Design Recommendation Meeting
6.22.2020
3033617-EG
3034294-LU
809 S Washington St

SECTION 02 / Board Guidance at EDG-2

Follies

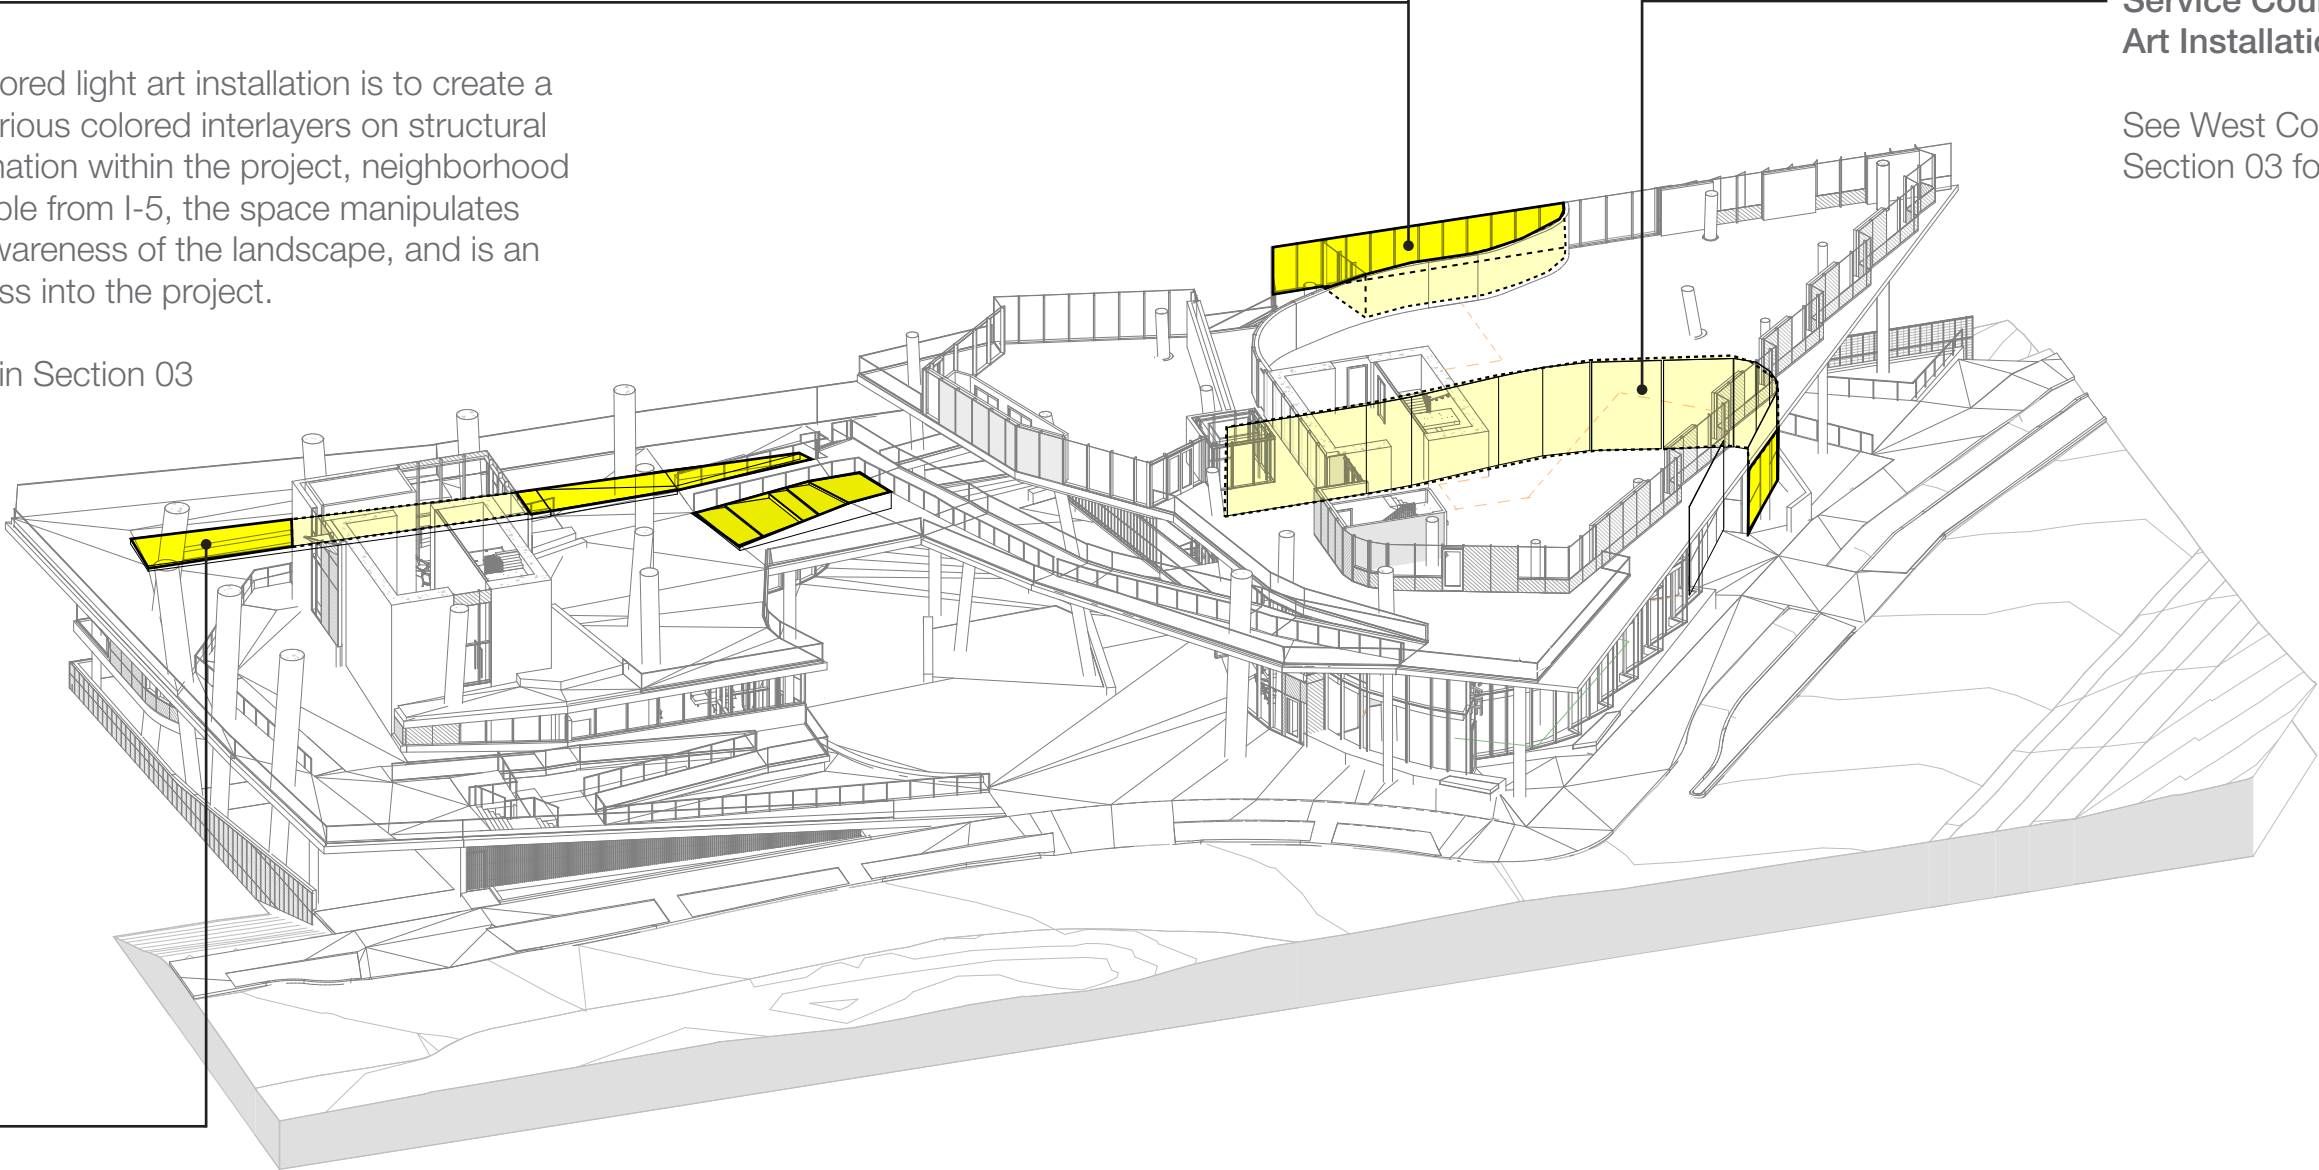
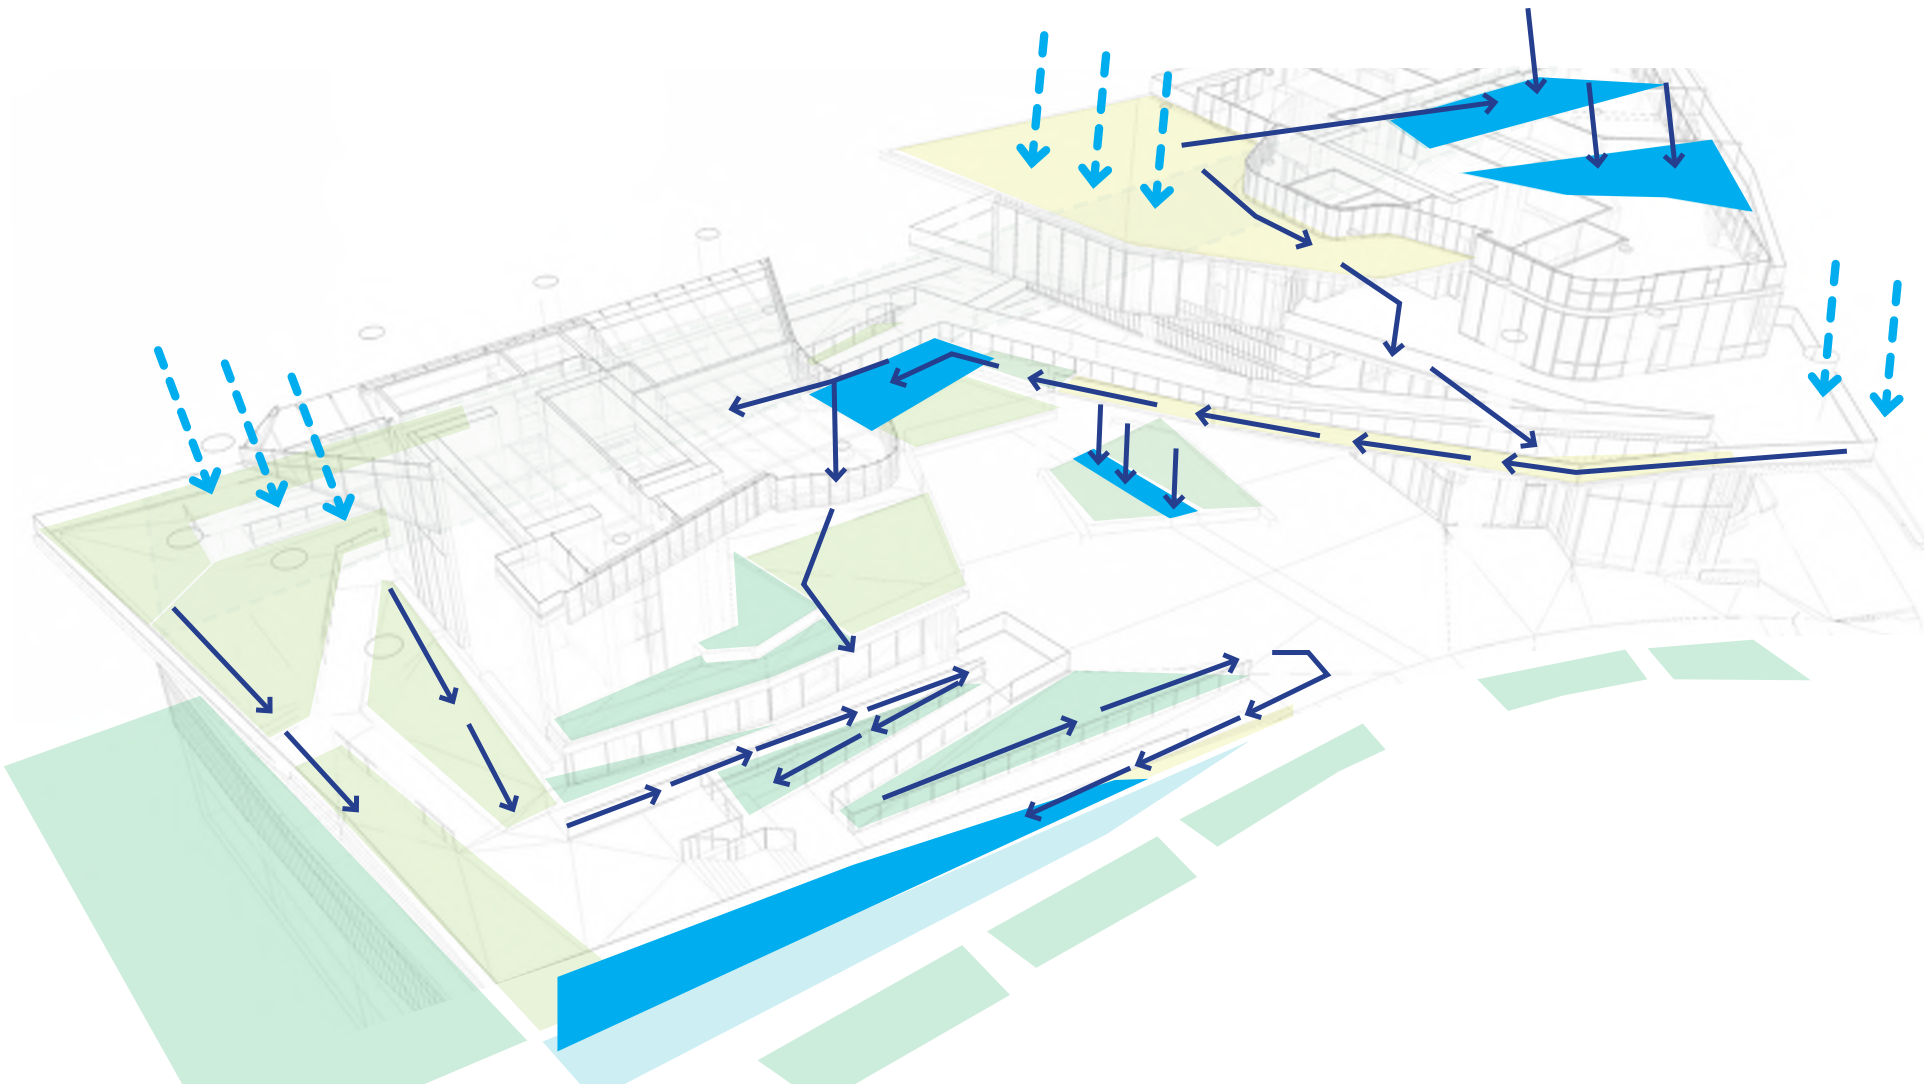
7A. Follies: The Board agreed that the details of the folly concept within the landscape plan were exciting and should be further explored and details at the next meeting. Specific information about the curation and themes will be critical. The opportunity for these elements to integrate cultural history of the neighborhood, as well as introduce playfulness and learning should be harnessed. The Board echoed public comment and noted that the cultural references expressed in the landscape design and folly elements should strive to reflect both the past communities of the neighborhood, as well as the present and future. (Yesler Terrace CS1-E Water, Yesler Terrace CS2 Wayfinding Kiosks)

At significant moments within the podium, follies will be introduced to enrich peoples experience, creating opportunities to heighten or change perceptions of natural phenomena, of time and place, or of the history of the site. These follies will encourage residents and the public to engage the building and landscape with moments of mystery, humor, and delight, and with each visit, a new and more complete understanding of place can emerge.

The concept for the proposed colored light art installation is to create a laminated glass enclosure with various colored interlayers on structural glass mullions to become a destination within the project, neighborhood and city. As an outlook space visible from I-5, the space manipulates visual perceptions, heightening awareness of the landscape, and is an opportunity to introduce playfulness into the project.

The western edge of Level 2 provides an opportunity to heighten visitor's perception of the western view under various lighting and weather conditions. A place to enjoy the Olympic mountains and Puget Sound at sunset, or to watch rainstorms roll in, the folly will provide a unique setting shared with the community.
